HISTORIC AND DESIGN REVIEW COMMISSION

August 04, 2021

HDRC CASE NO: 2021-338
ADDRESS: 411 DEVINE ST
LEGAL DESCRIPTION: NCB 2957 BLK 1 LOT E 40 FT OF 3 & W 5 FT OF 4
ZONING: R-5, H
CITY COUNCIL DIST.: 1
DISTRICT: Lavaca Historic District
APPLICANT: Timothy Saenz/SAENZ TIMOTHY J & FRANCES W
OWNER: Timothy Saenz/SAENZ TIMOTHY J & FRANCES W
TYPE OF WORK: Skirting modifications
APPLICATION RECEIVED: July 08, 2021
60-DAY REVIEW: Not applicable due to City Council Emergency Orders
CASE MANAGER: Rachel Rettaliata

The applicant is requesting a Certificate of Appropriateness for approval to remove the existing flashing around the perimeter of the house and install stucco skirting 1-foot below the grade to extend 16 inches above the grade.

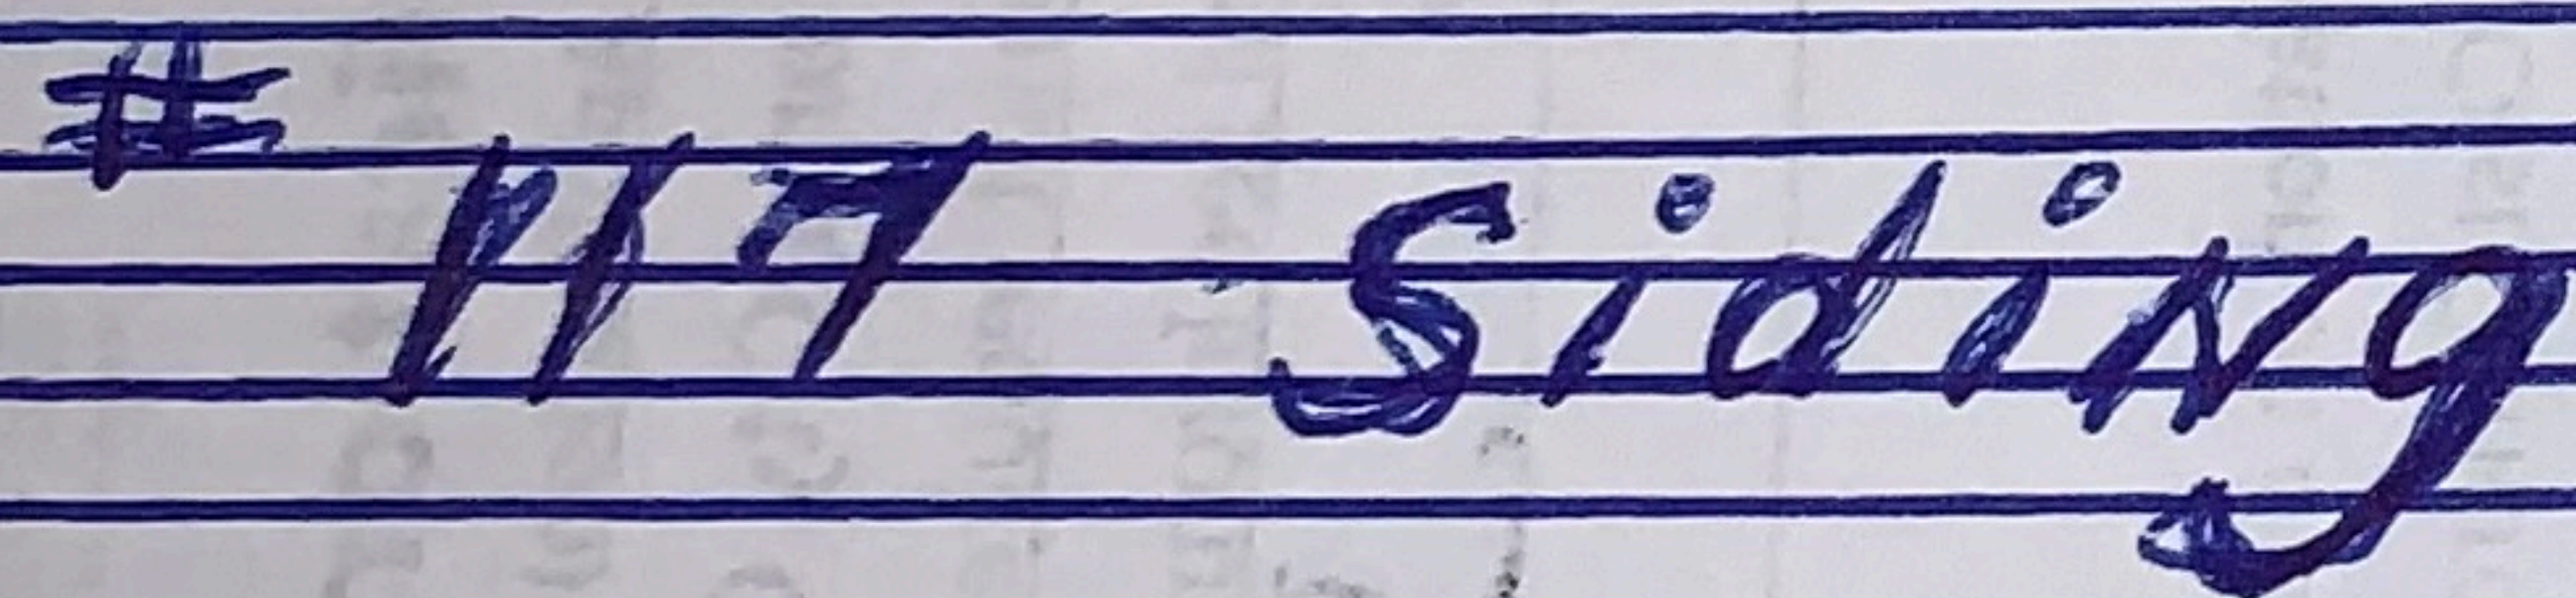
Staff does not recommend approval of the stucco skirting installation based on findings a through b. The installation of skirting to match the existing wood siding or a cement board product that mimics the appearance of existing siding with a smooth finish is eligible for administrative approval.
